15th Avenue & Como

Station concept

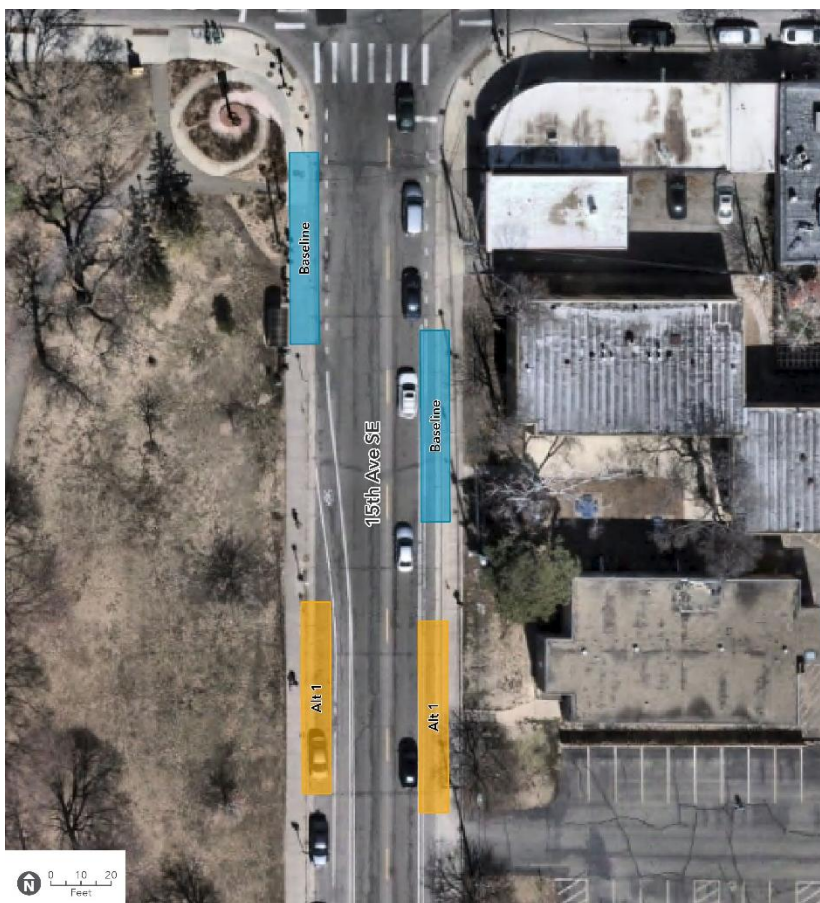
The 15th Avenue & Como Station platforms were evaluated in response to changes to the roadway that will occur with Minneapolis' Como Avenue SE Corridor Improvement Project and implementation of separated bike lanes at H Line platforms. These roadway changes will narrow 15th and Como avenues.

The change in roadway width is expected to increase traffic congestion at the 15th Avenue and Como Avenue intersection enough to negatively impacting bus speed and reliability. Freight truck turn accommodations did not work under the baseline station location due to a narrowing of the south leg of the intersection on 15th Avenue. Relocating the 15th Avenue & Como Station platforms allows for more space at the 15th Avenue and Como Avenue intersection.

An alternative moving H Line station platforms mid-block on 15th Avenue between Como Avenue and Brook Avenue was evaluated:

- Baseline Alternative: 15th Avenue & Como Station
- Alternative 1: 15th Avenue & Como Station sited mid-block between Como Avenue & Brook Avenue

Following review, Metro Transit project staff recommend moving the 15th Avenue & Como Station platforms south, approximately 200 feet from the intersection. Moving both station platforms further south of Como Avenue results in improved traffic operations and reduced delay, which benefits H Line speed and reliability. Moving station platforms also improves truck turning movements by allowing for a wider intersection. 15th and Como avenues are both City of Minneapolis truck routes and are required to accommodate freight trucks. The Alternative 1 platform locations will be implemented along with

crossing improvements at Brook Avenue, south of the station, to facilitate a safer crossing of the unsignalized intersection.
